This letter will serve as our response to your letter of inquiry dated 15 March 2006 regarding our recent materials license application. (**Control #138341; Docket #03037131**) Our responses will follow your numbers as written.

Summersville Memorial Hospital Request for Additional Information
Materials Application Docket #03037131 Control #138341
20 March 2006 Rev. 1

Summersville Memorial Hospital Floor Plan Layout Hot Lab and Scan Room

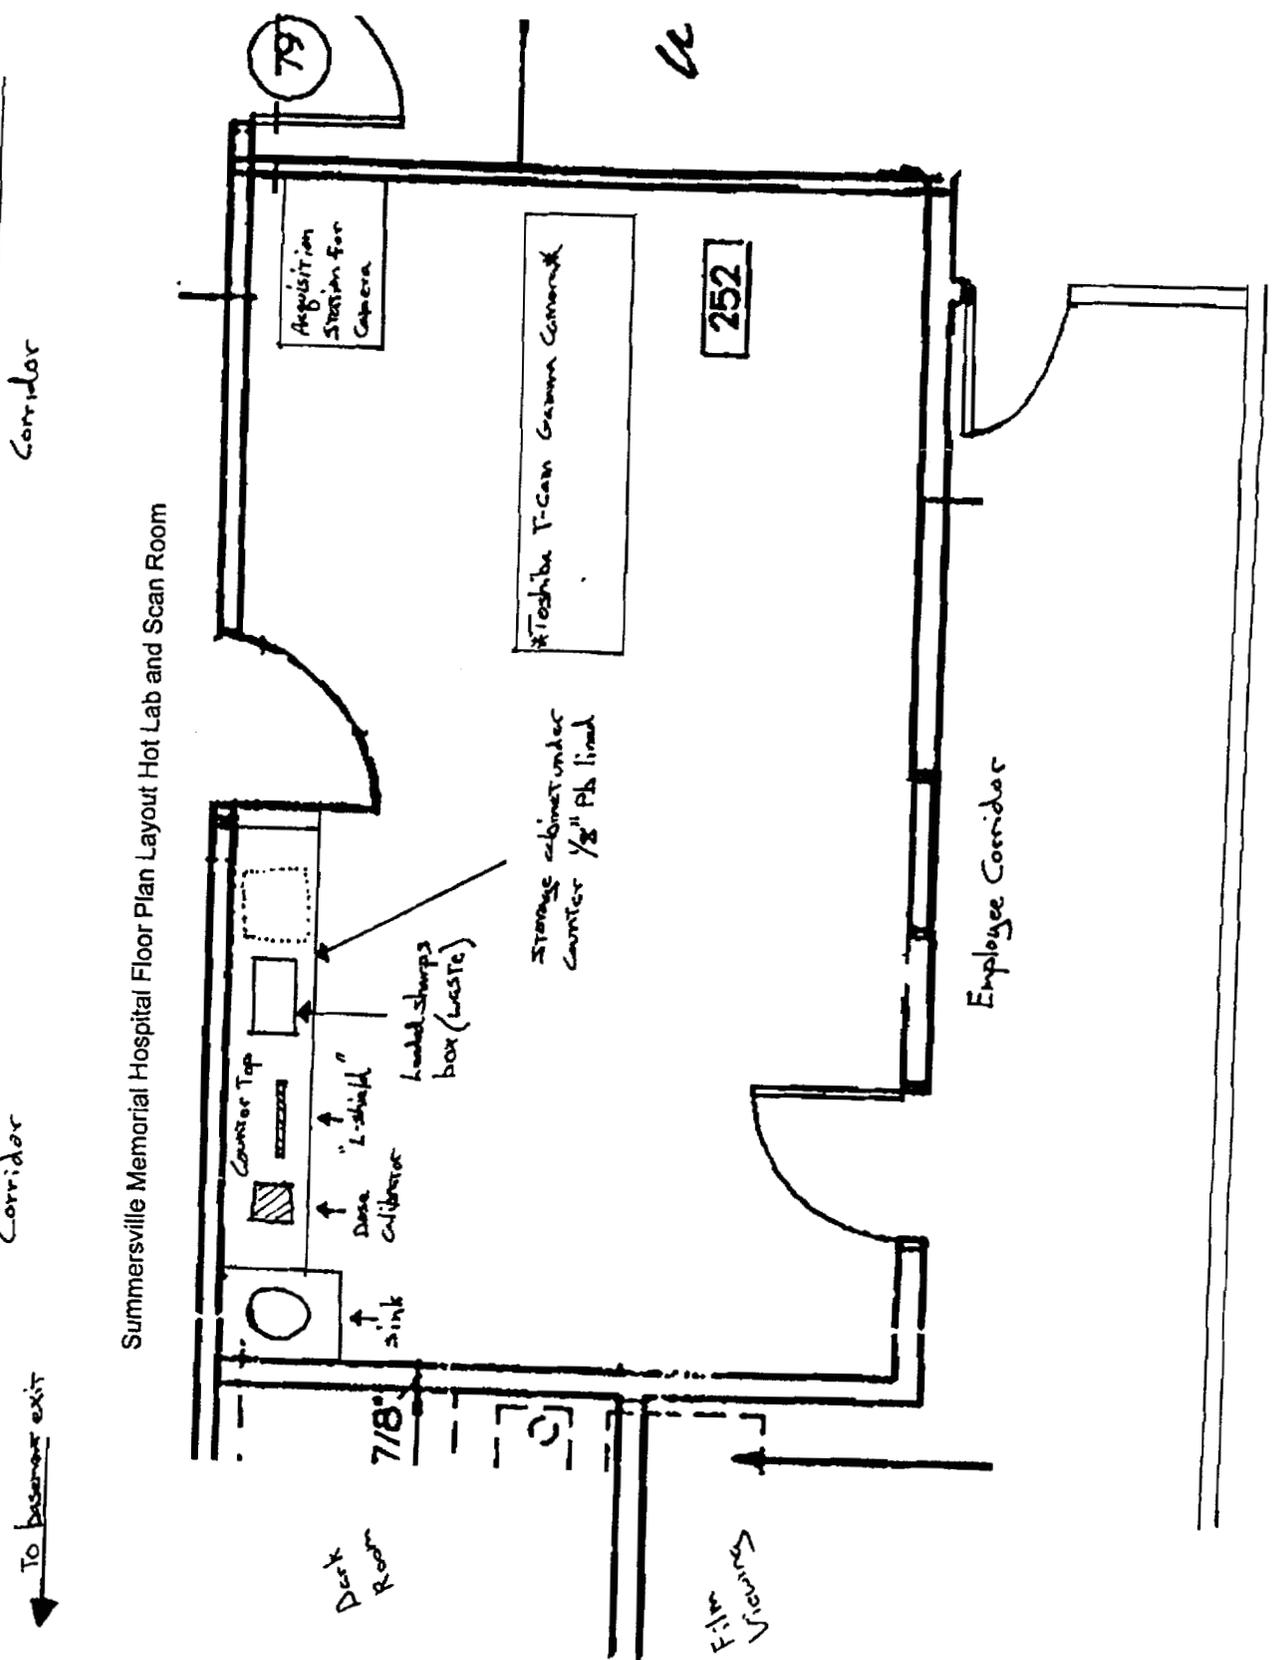
6. Please see the attached floor plan for details.
 - a. We will store radiopharmaceuticals in the shipping containers from the pharmacy. (lead batons and "ammo can")

- b. Radioactive waste will be stored in leaded waste containers (sharps bins) that have been purchased from Biodex, Inc. Also, we are constructing a 1/8" lead lined cabinet for storage of radioactive waste under the counter top.

- c. Please see the diagram for location of dispensing area.
7. Our radiation detection instruments are as follows;
 - a. 2 Ludlum 14C GM survey meters with model 44-9 (Pancake style) probes.
